POLICY ISSUE
(Notation Vote)

SECY-91-220

Subject: YANKEE ROWE PRESSURE VESSEL EMBRITTLEMENT ISSUES

PROPOSED DECISION UNDER 10 CFR SECTION 2.206

Fig. 1 P(F|E) per reactor year as a function of copper content for residual stress levels of 0 ksi, 6 ksi and 10 ksi.

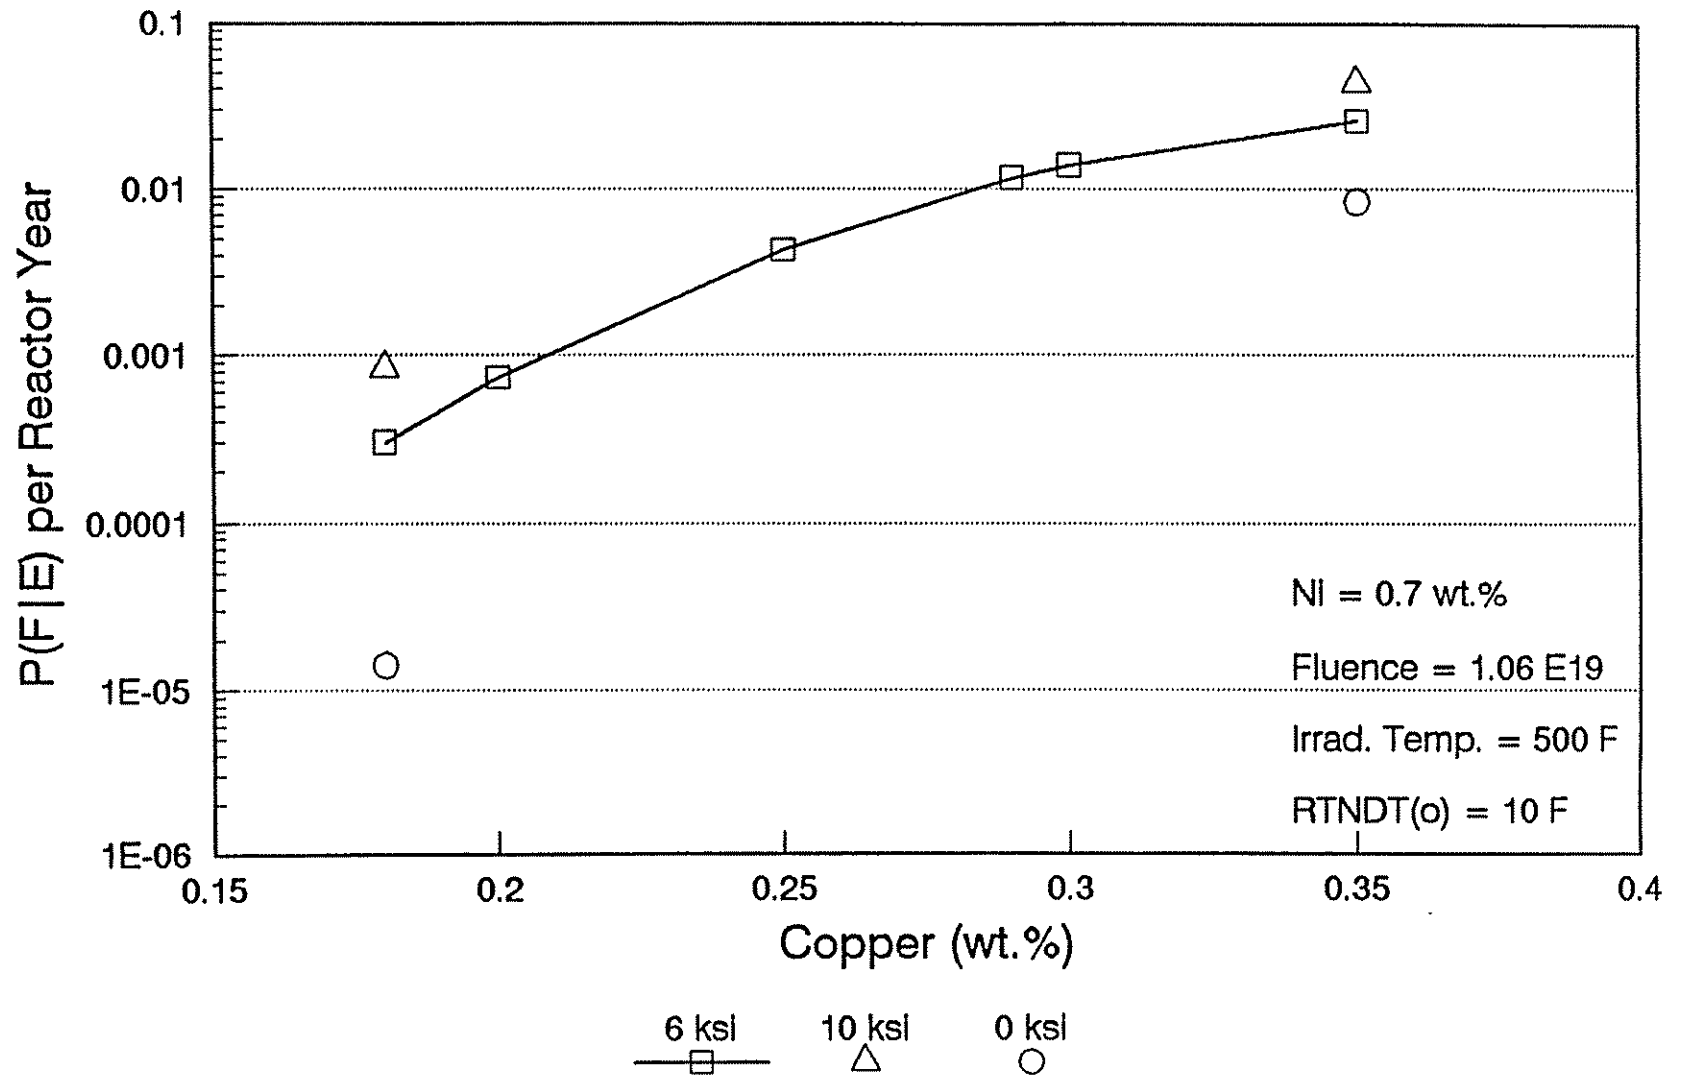
The sensitivity of $P(F|E)$ to various levels of residual stress is illustrated in Figure 1, which examines the effect of copper content at three residual stress levels. As with the other variables, residual stress has a relatively large effect at low copper contents, but a much smaller effect at high copper levels.

Fig. 3 P(F|E) per reactor year as a function of neutron fluence for copper levels of 0.18, 0.29, and 0.35 wt.%.

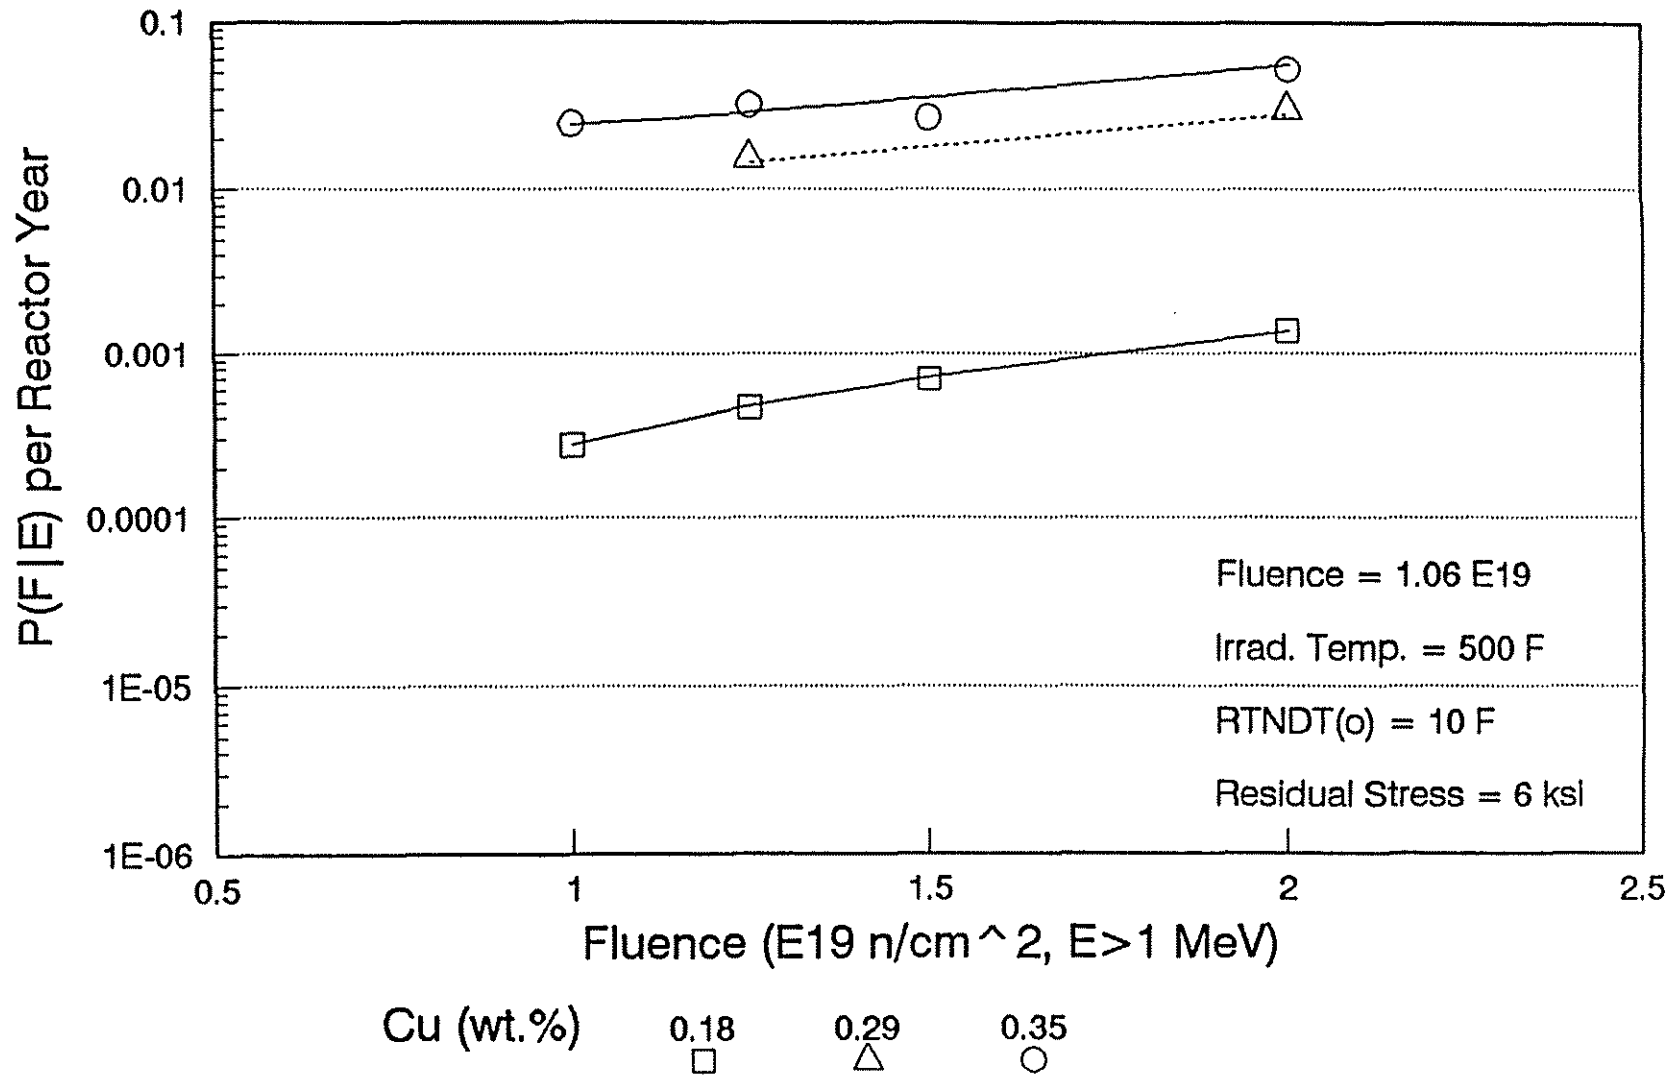
Figure 3 demonstrates the sensitivity of $P(F|E)$ to fluence for three copper concentrations, all at 0.7 wt.% Ni. For 0.18 wt.% Cu, varying fluence by a factor of 2 varies $P(F|E)$ by a factor of 5. However, for 0.35 wt.% Cu, varying the fluence by a factor of 2 only changes $P(F|E)$ by a factor of 2.

Fig. 4 P(F|E) per reactor year for initial RT_{NDT} values of 0, 10, and 20°F at copper levels of 0.18 and 0.25 wt.%.

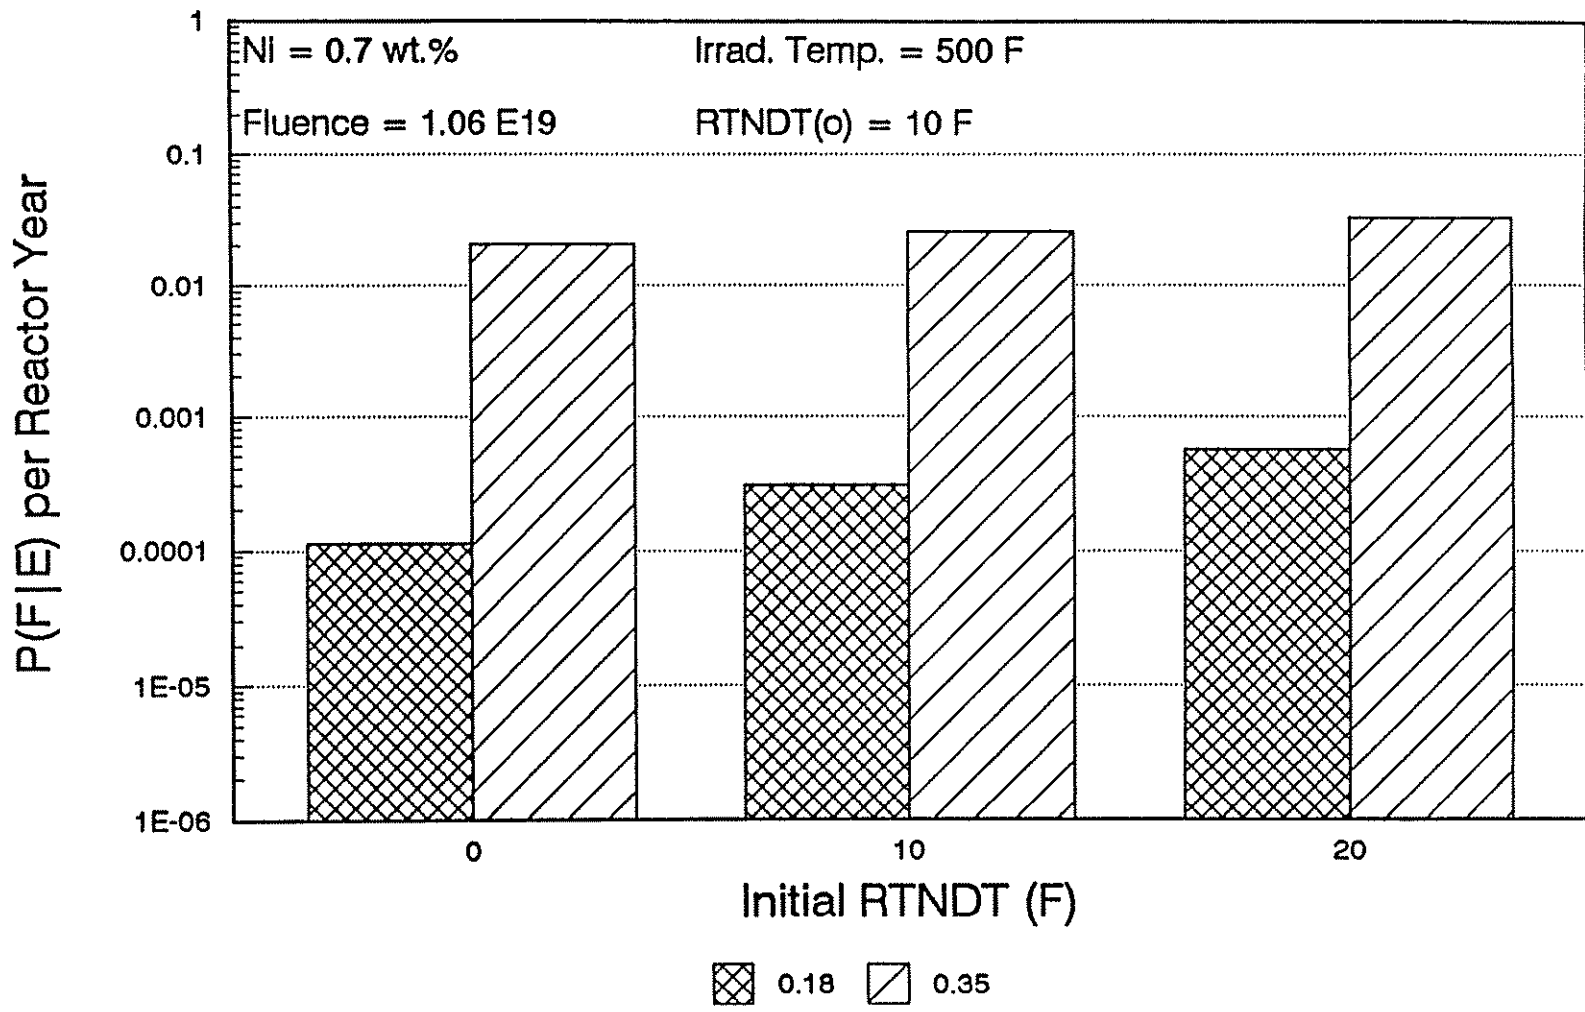
Figure 4 demonstrates the effect of changes in initial RT_{NDT} for two copper concentrations, at 0.7 wt.% Ni. At 0.18 wt.% Cu, changing the initial RT_{NDT} from 0°F to 20°F increases $P(F|E)$ by a factor of 5. However, at 0.35 wt.% Cu, this same increase in initial RT_{NDT} only increases $P(F|E)$ by a factor of 1.6.

Fig. 5 P(F|E) per reactor year for irradiation temperatures of 500 and 550°F at copper levels of 0.18, 0.29, and 0.35 wt.%.

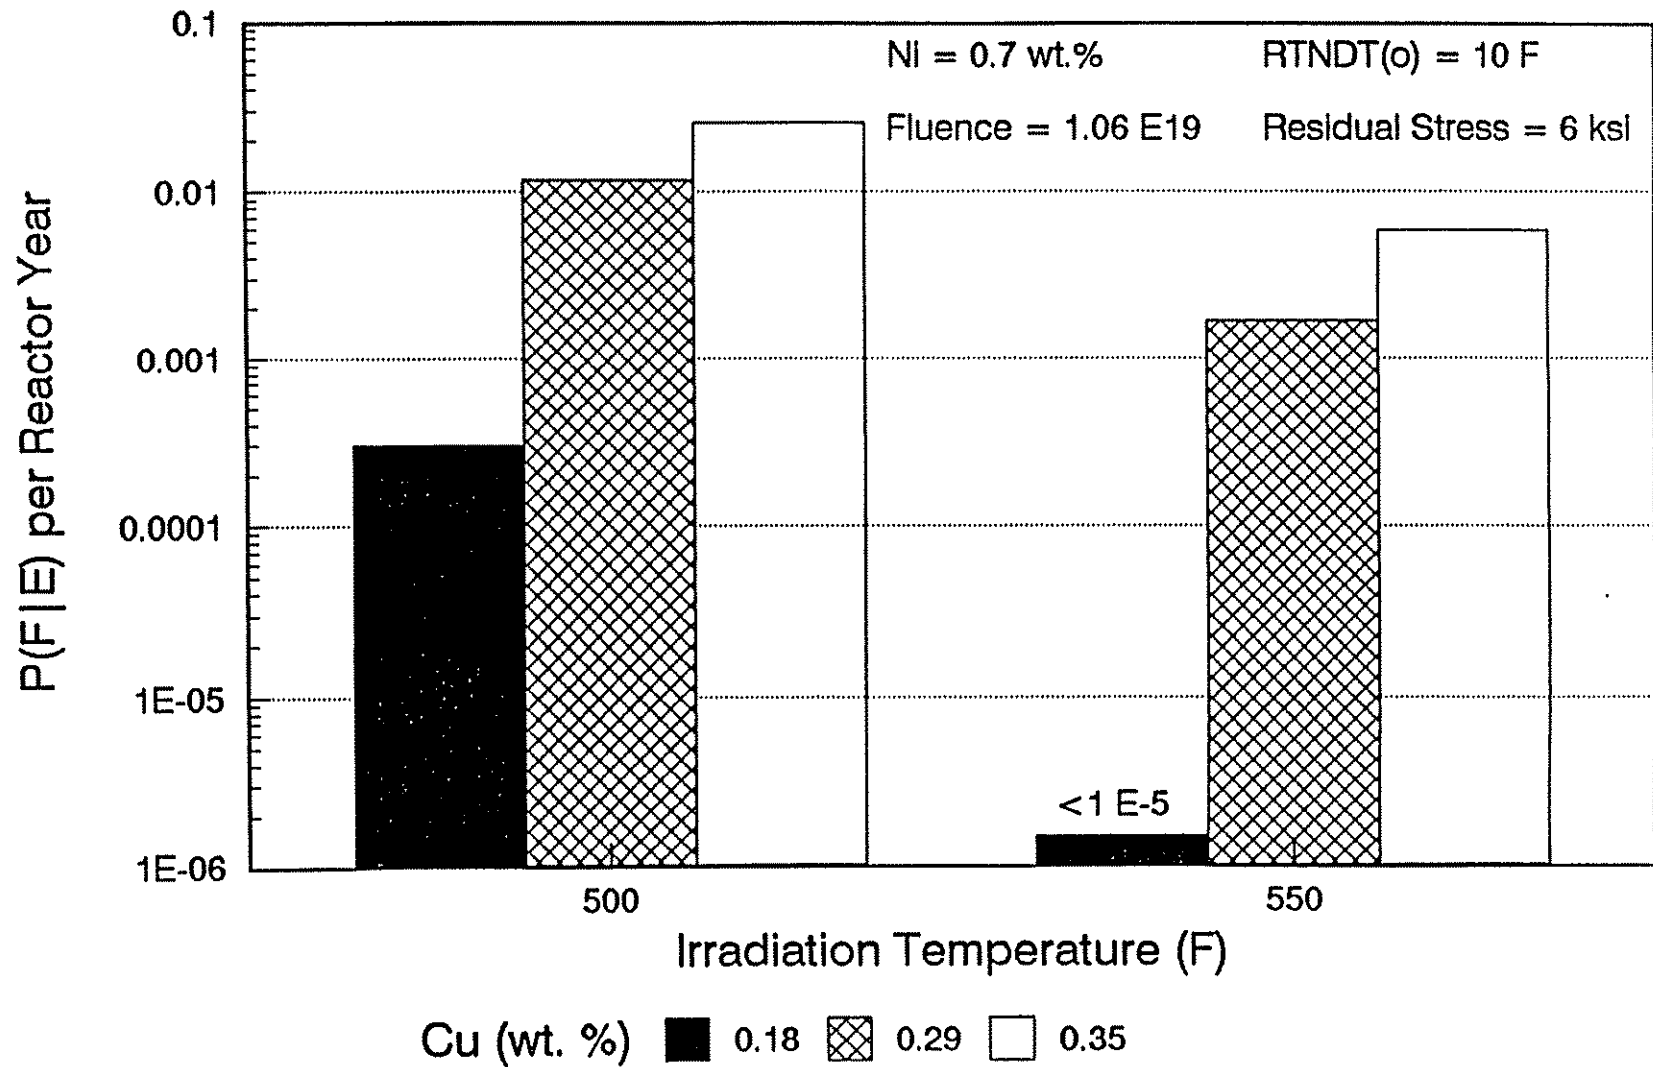
Figure 5 demonstrates the effect of irradiation temperature for three copper concentrations, all at 0.7 wt.% Ni. Irradiation temperature is included in the analysis by increasing the initial RT_{NDT} by 1°F/°F for irradiation below 550°F. For Yankee Rowe, that is a 50°F increase. From Figure 5, it is clear that for low Cu, irradiation at 550°F has a very significant effect -- more than 2 orders of magnitude reduction in $P(F|E)$. However, for higher copper concentrations, irradiation temperature has a much smaller effect. Obviously, this is the same trend observed for changes in the initial RT_{NDT} .

Fig. 6 P(F|E) per reactor year for the Marshall flaw size distribution and the Dufrense and Lucia flaw size distribution.

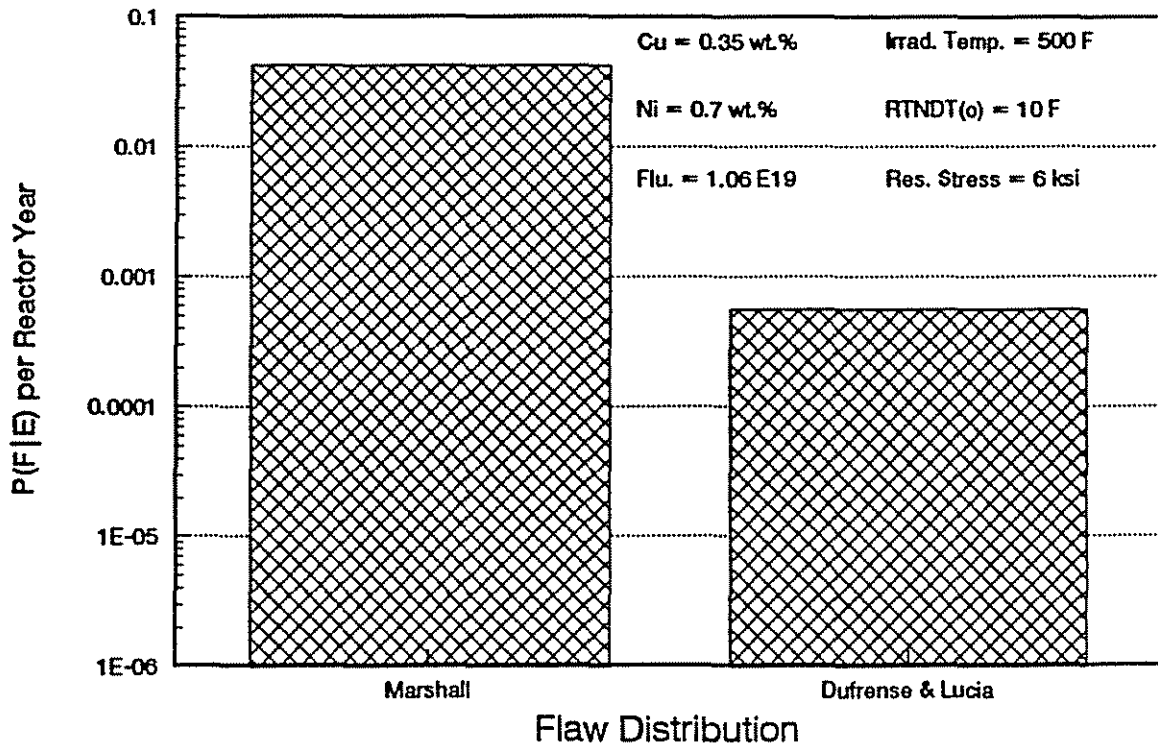
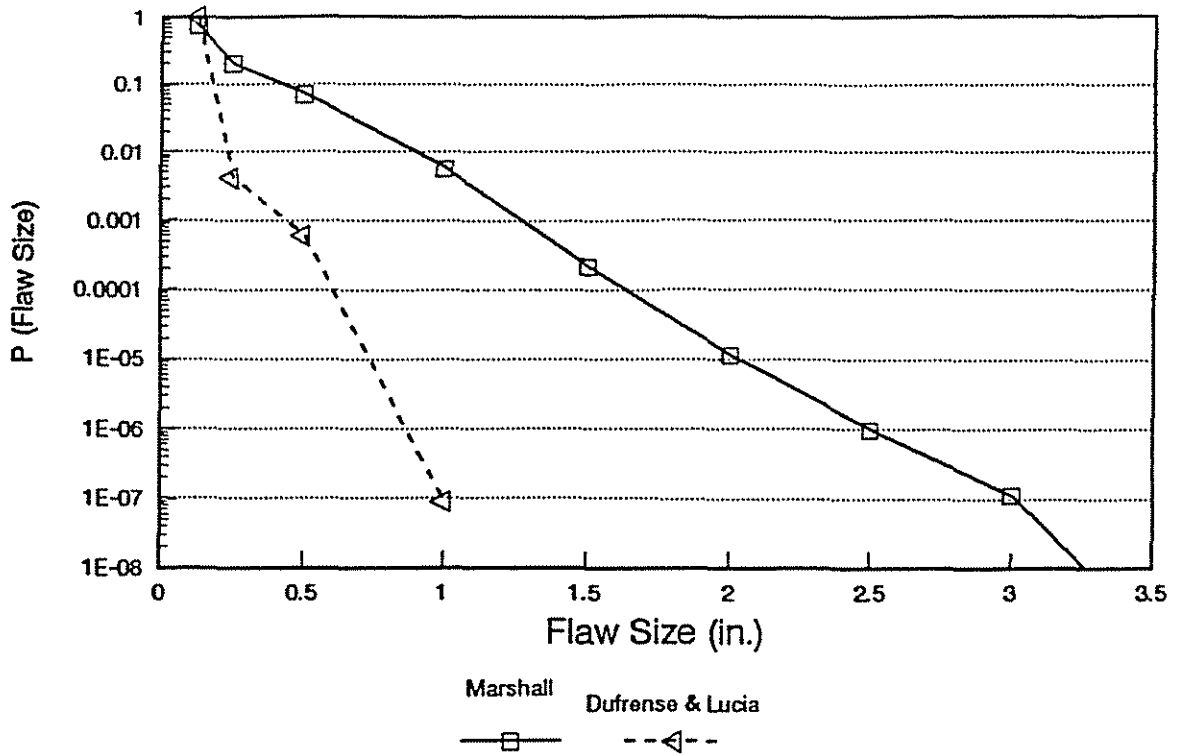
Figure 6 demonstrates the effect on $P(F|E)$ of the Marshall flaw size distribution versus the Dufrense and Lucia distribution. Figure 6(a) shows the two flaw distributions, and Figure 6(b) shows their effect on $P(F|E)$. This comparison was made for 0.35 wt.% Cu and 0.7 wt.% Ni. For these conditions, changing from the Marshall distribution to the Dufrense and Lucia distribution reduces $P(F|E)$ by a factor of 75. A slightly greater reduction -- a factor of 84 -- was observed for 0.26 wt.% Cu and 0.62 wt.% Ni. The reduced sensitivity to changes in chemistry simply is reflecting the fact that the flaw size distribution does not impact the level of embrittlement.

Fig. 7 P(F|E) per reactor year as a function of flaw density.

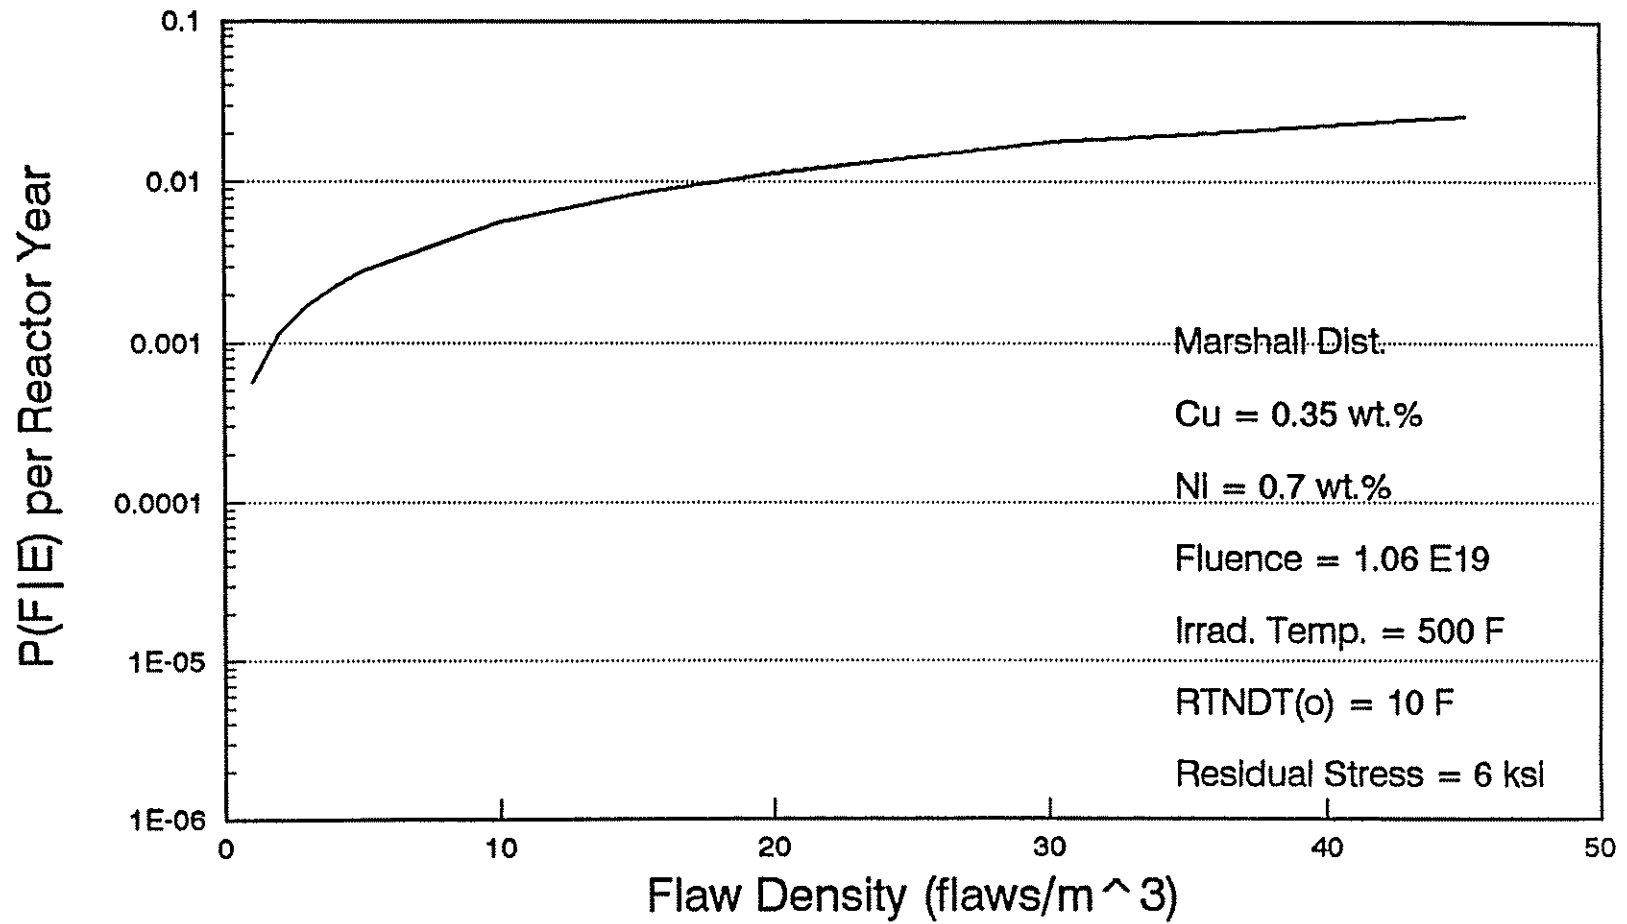
Figure 7 demonstrates the effect of $P(F|E)$ of changes in the flaw density. This simply relates to the number of flaws in the pressure vessel and, below approximately 100 flaws/m³ the relationship is linear. Above that value the relationship is nonlinear and was not treated by the staff in this analysis. It has been treated in an approximate manner in earlier work examining other reactor pressure vessels -- see NUREG/CR-4183. However, for the purposes of the present study, the limitation is not significant.
